PLAN CHANGE REQUEST

1. PROJECT: WALMART PICKUP EXPANSION ADDRESS: 310 31ST AVE
2. OWNER: WAL-MART RE BUSINESS TR 2403 EMAIL: jose.castro@wdpartners.com
3. DESIGN ENGINEER: GALLOWAY EMAIL: brandonalley@gallowayus.com

START CONSTRUCTION CHANGE DIRECTIVE CCD#7

START CONSTRUCTION CHANGE DIRECTIVE CCD#8

SHEET: CS7

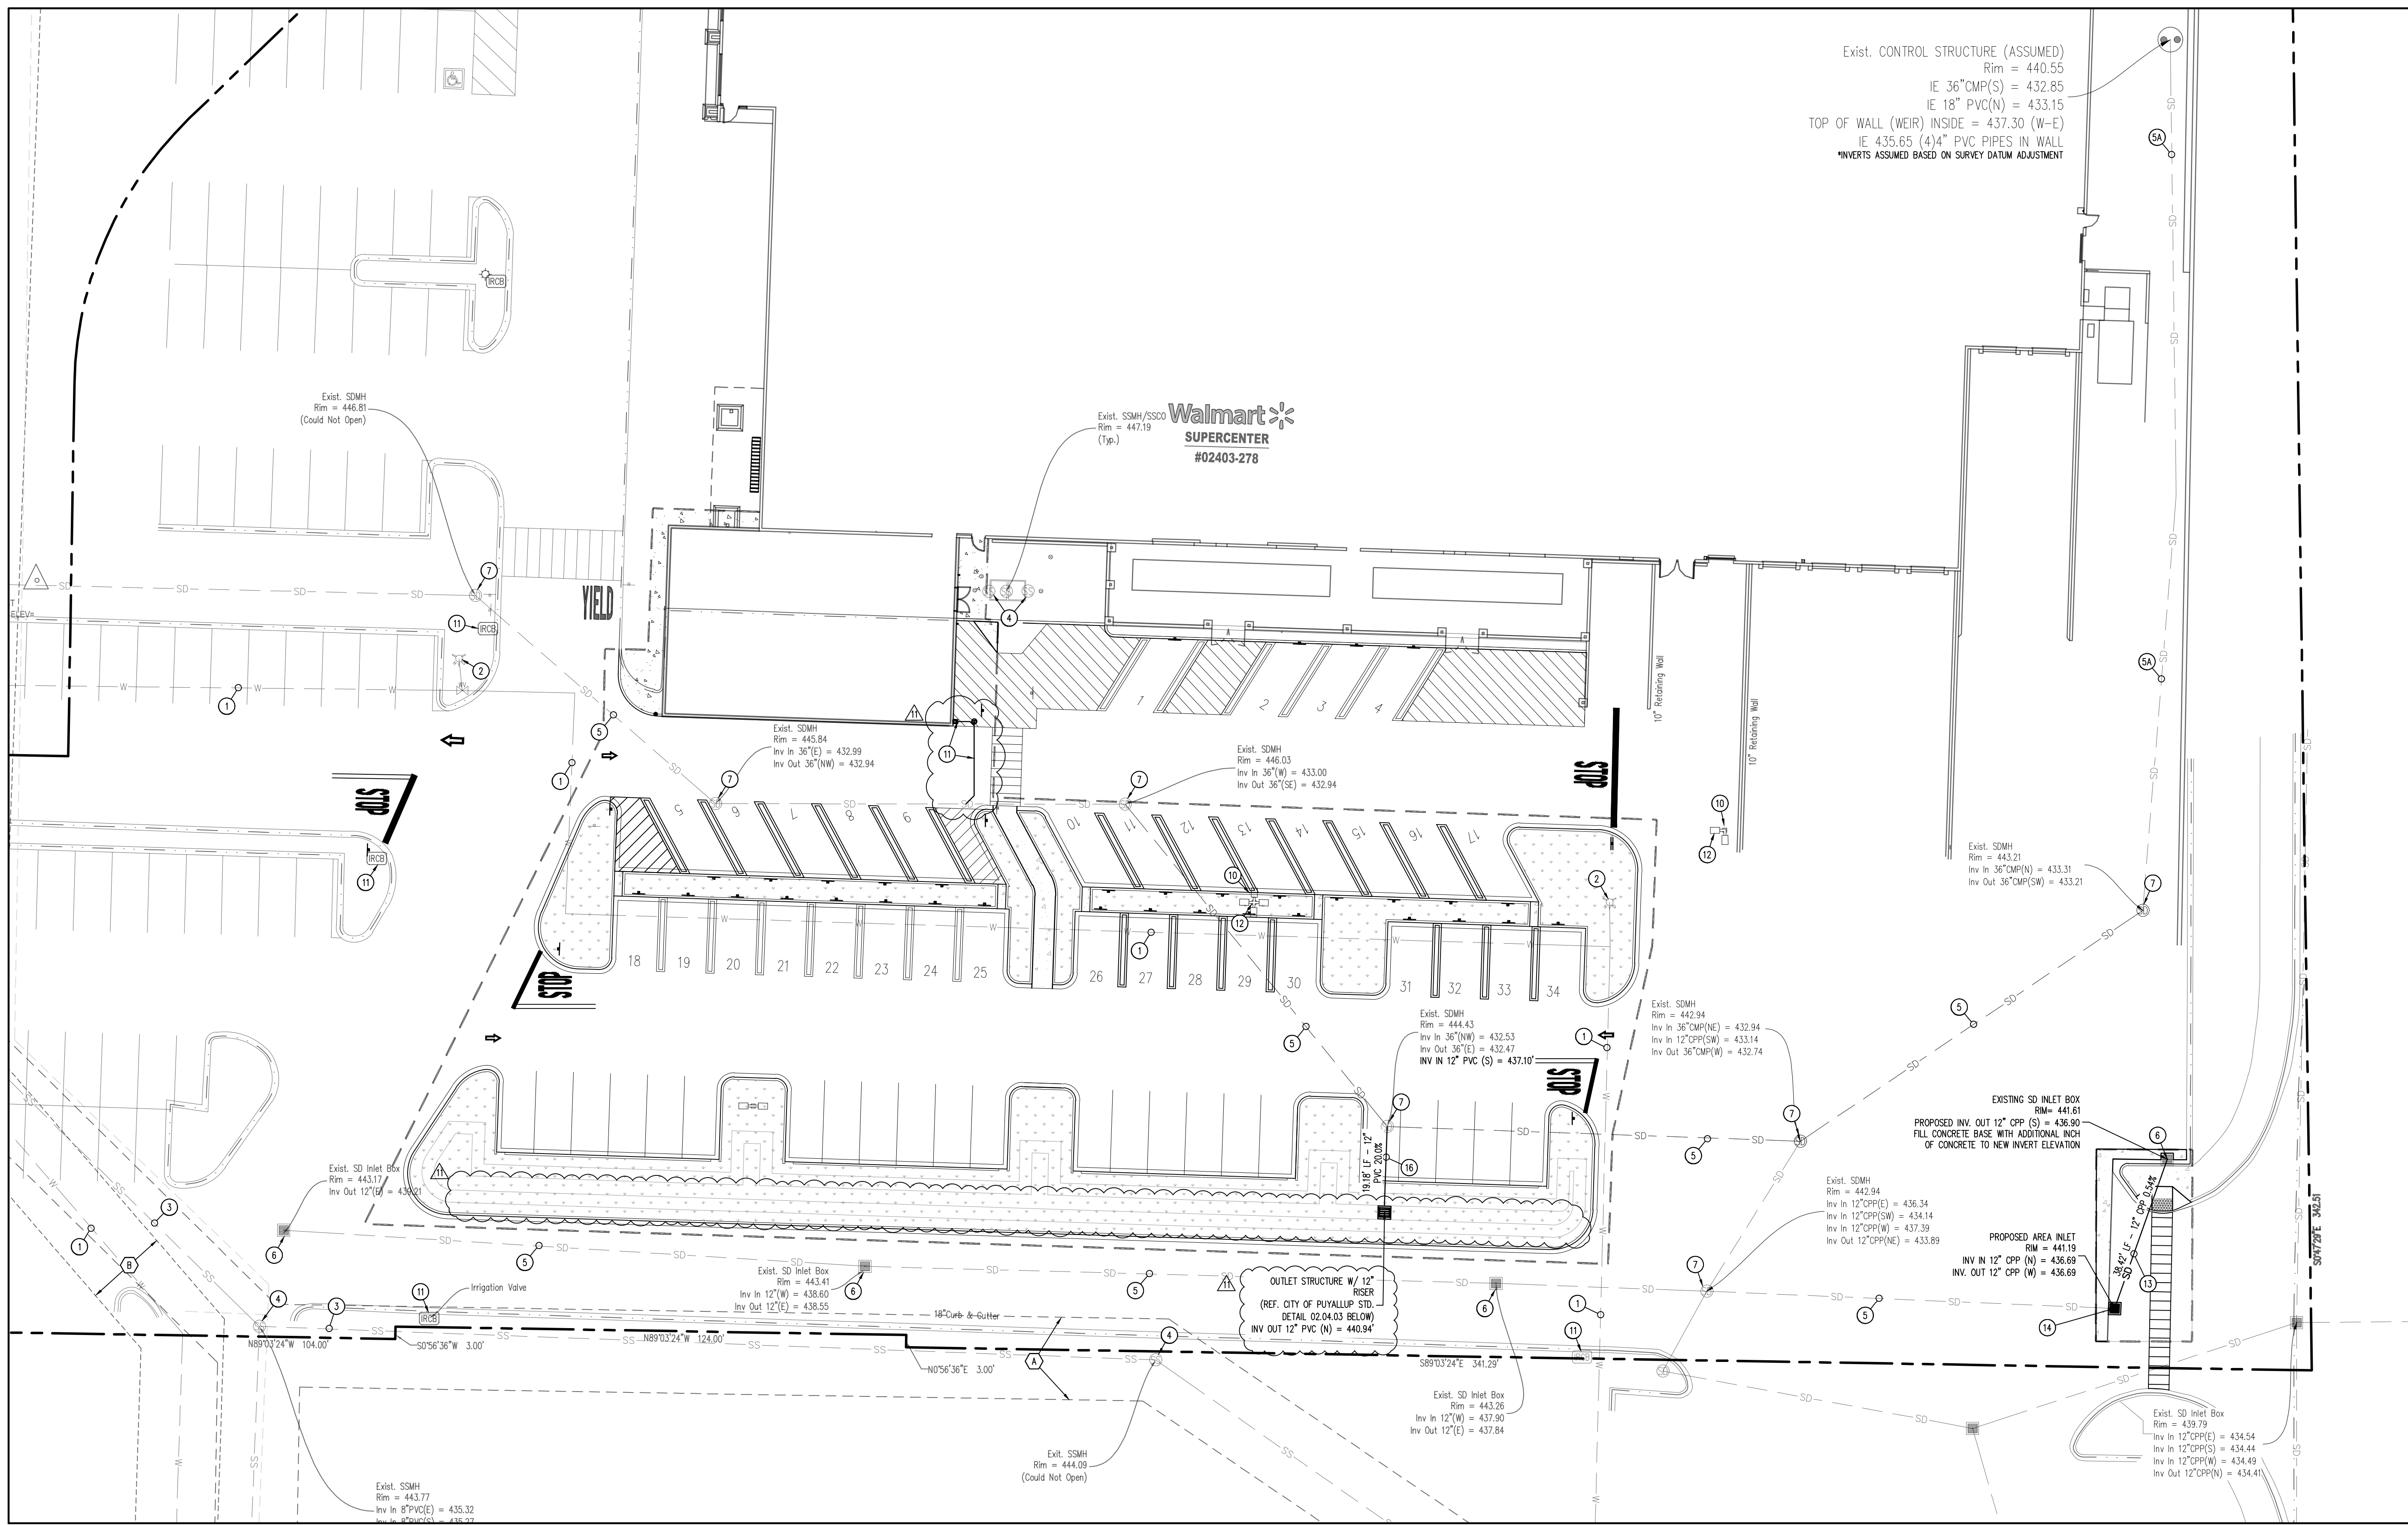
6007 – CS7 Utility Plan

1. Add roof drain routing from building.
2. Remove underdrain from bioretention.
